CITY OF FORT COLLINS TYPE 1 ADMINISTRATIVE HEARING FINDINGS AND DECISION

PROJECT NAME: Stoner Subdivision Major Amendment

CASE NUMBER: MJA #130045

PROJECT: Stoner Subdivision Major Amendment MJA #130045

Lot 2, Stoner Subdivision, Major Amendment

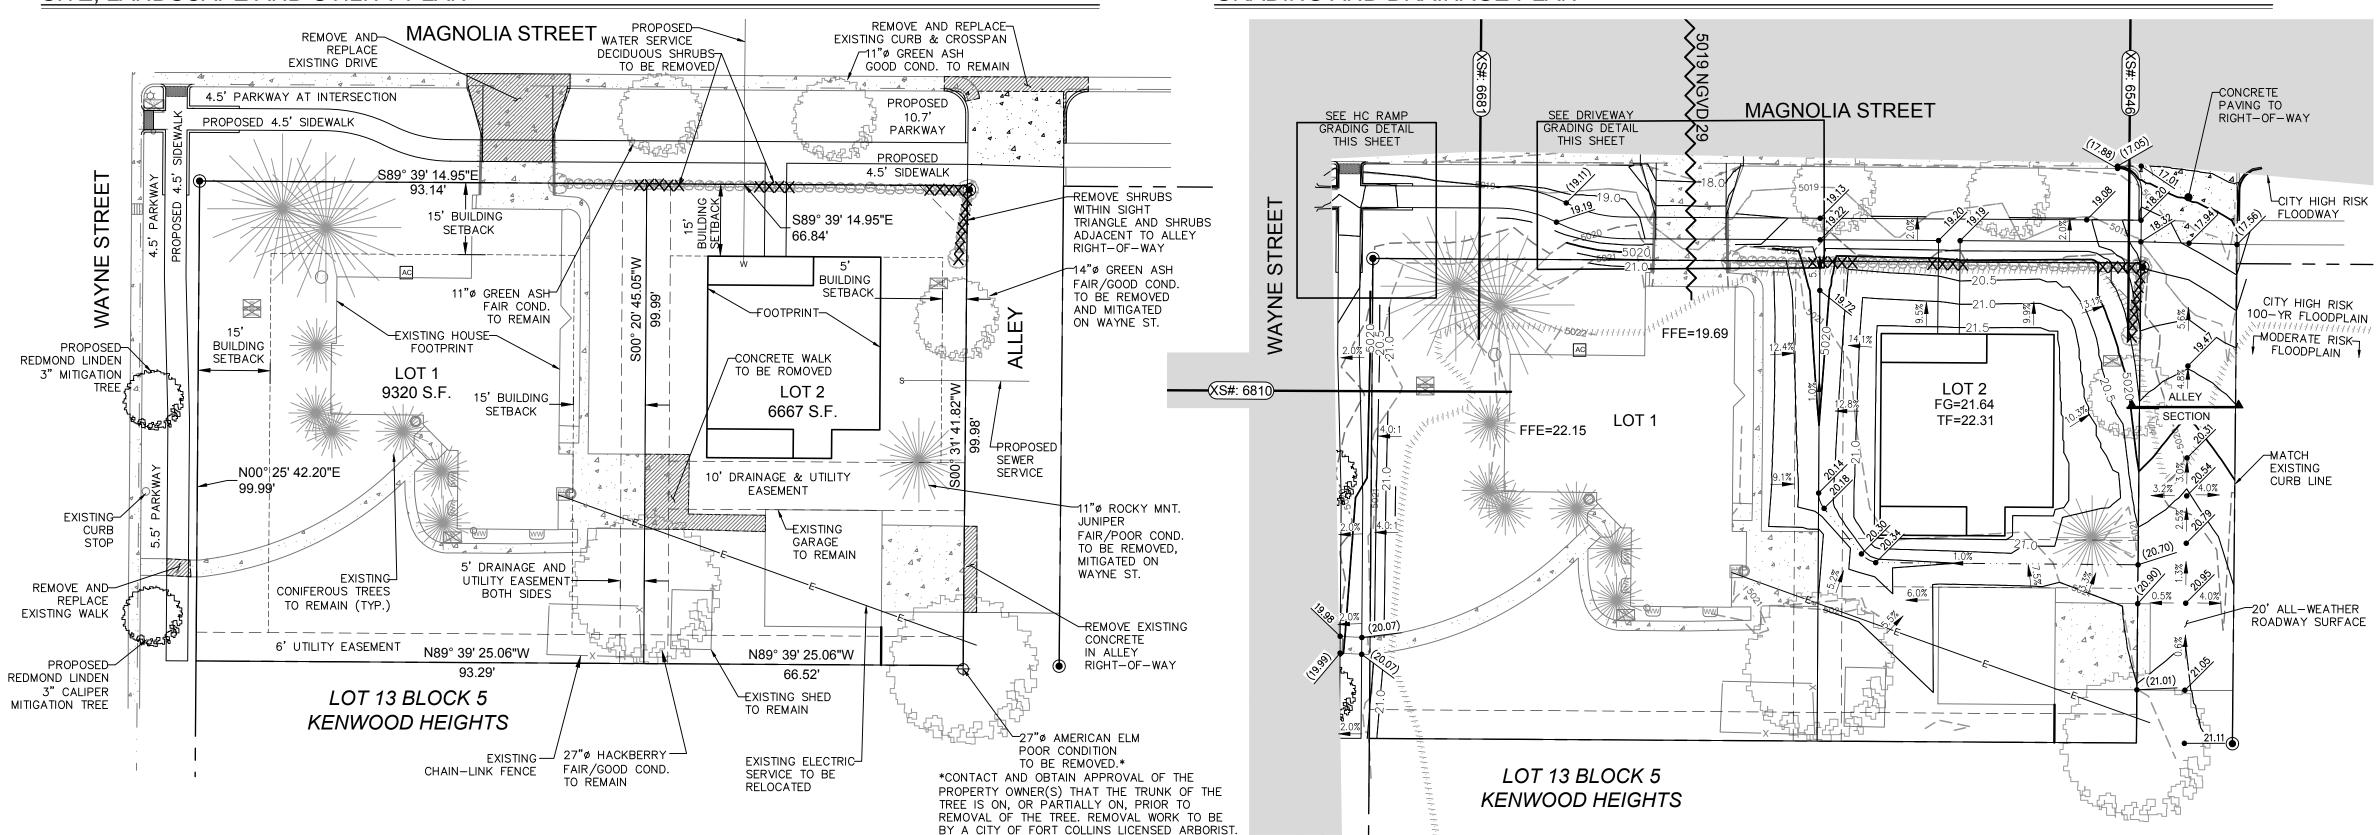
The proposed major amendment to the approved building design does not comply with the building and compatibility standards of this section in terms of scale, height and massing.

- The proposed design does not achieve <u>compatibility</u> with the homes near or adjacent to the project. The proposed design contains a significant amount of competing building forms, causing the overall bulk and massing to be inconsistent with the character of adjacent one-story homes as well as nearby homes. A single primary building form is not clearly defined, and the multiple forms used do not have sufficient hierarchy within the forms to keep the overall massing from appearing out of scale with homes in the area.
- The second story has no floor area that is contained within the roof line of the first story, which is a predominant characteristic of the architecture in the area.
 The significant quantity and location of competing wall and roof planes used with

the design is inconsistent with the simple wall and roof forms of nearby architecture. The second story floor area is defined by vertical walls that extend to the top of the second-story windows, and this floor area extends over a large portion of the first story, adding to the inconsistently large bulk and mass of the building. The overall affect is a second story that is not secondary to an overall primary form, and appears as a dominant form on top of another dominant form, which is inconsistent with the architectural context in the area. Elements of the building design are not arranged to control the height, scale, mass and bulk in a way that is compatible with architecture in the surrounding area. The resulting proposed design is incompatible, does not achieve sensitivity in maintaining the character of existing development and does not preserve the character of developed single-family dwellings in accordance with the purpose statement of the N-C-L District.

1. The MJA is hereby approved as submitted.
